# DEVELOPMENT REVIEW COMMITTEE (DRC) COMMENT REPORT

**PROJECT NAME:** 201 N Federal

**CASE NUMBER:** UDP-S22081

**REQUEST:** Site Plan Level II Review: Mixed-Use Development with 824 Multifamily Residential Units and 10,399 Square-Foot Commercial Use in Downtown Regional Activity Center

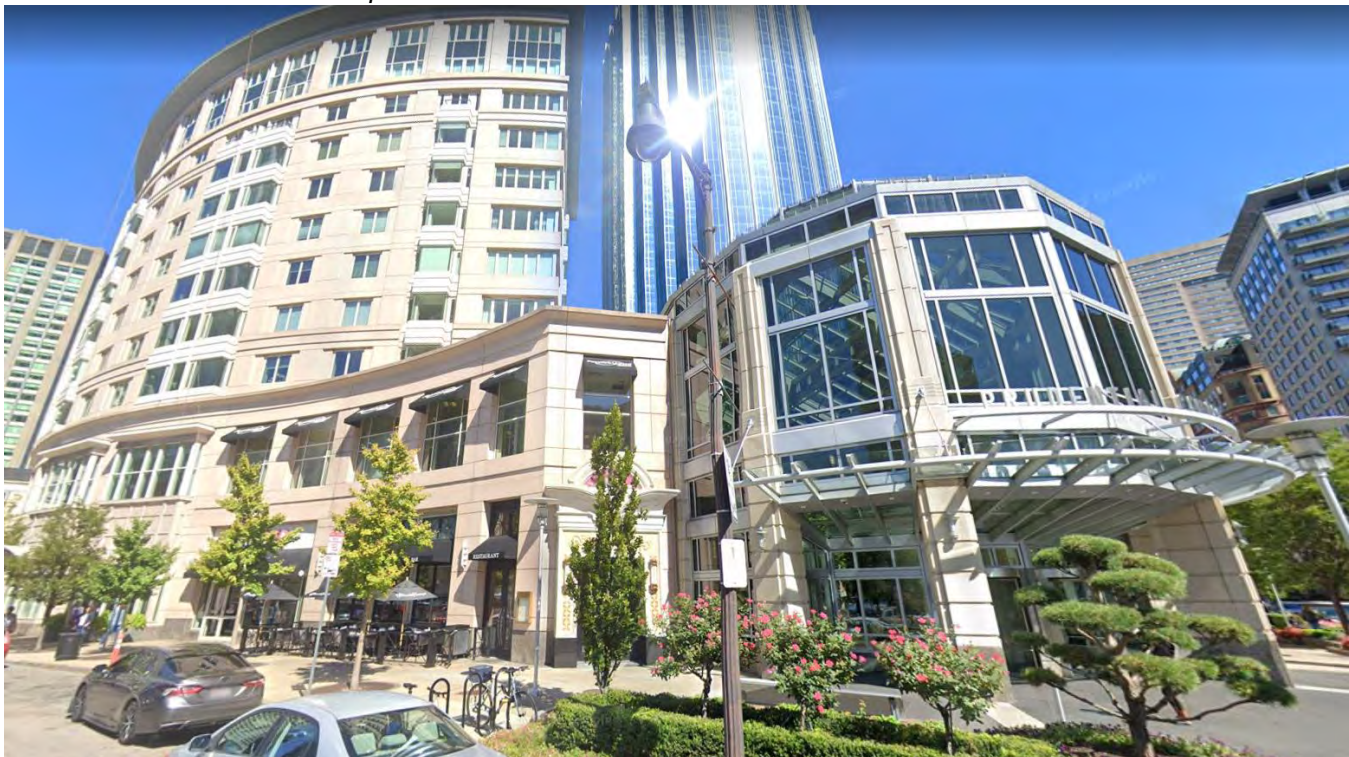
Furthermore, to better activate NE 2<sup>nd</sup> Street, relocate the FPL vault to NE 3<sup>rd</sup> Street along the northern entrance, and convert the internalize drive to a south bound one way movement, relocating valet operations within the internalized drive. Widen the internal drive south of the garage ramp to accommodate an internalized valet pickup area and provide adequately sized sidewalks for pedestrians. The removal of the NE 2<sup>nd</sup> Street drop-off lane allows for additional street activation and potential incorporation of commercial floor area. Reference examples, below:
